Leisure World Administration Building and Clubhouse I, Site Plan No. 820170120

Completed: 11/17/17

DATE: 12-Oct-17
TO: Kim Currano - kim.currano@stantec.com
Stantec
FROM: Marie LaBaw
RE: Leisure World: Administration Building & Clubhouse 1
820170120

Re: **COMBINED STORMWATER MANAGEMENT
CONCEPT/SITE DEVELOPMENT
STORMWATER MANAGEMENT PLAN** for
Leisure World Administration Building
Preliminary Plan #: 820170120
SM File #: 282935
Total Concept Area: 3.25 acres
Parcel(s): 4 and 63
Watershed: Northwest Branch

Figure 6: Plaza at the main entrance to the new Administration Building

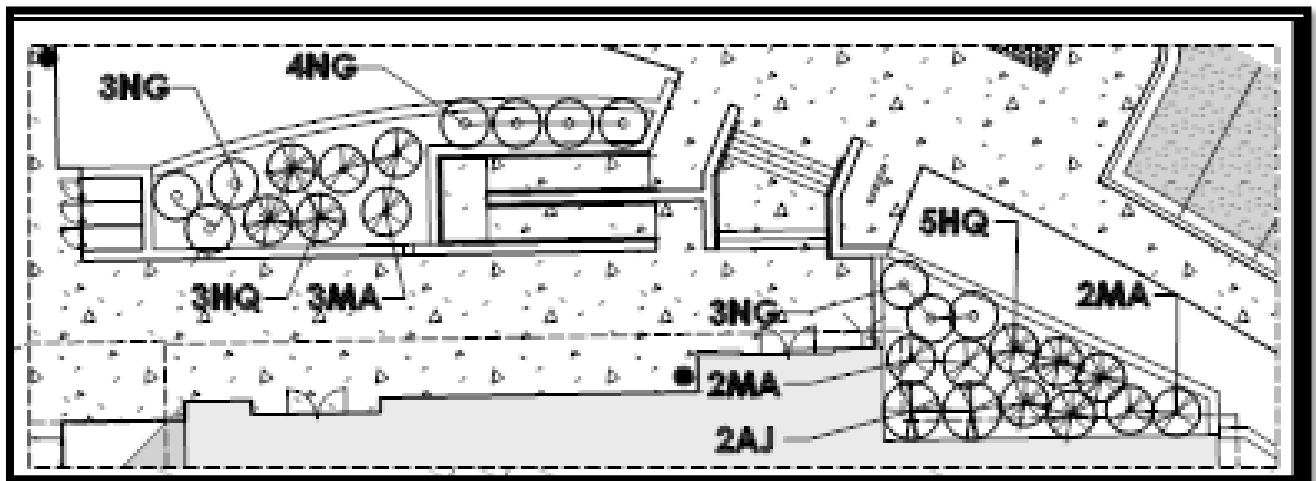
- d) Revise the layout and design of the Administration Building's entrance plaza to be substantially similar to the sketches prepared by Staff as part of the last review comments or, provide a Staff-approved alternative.
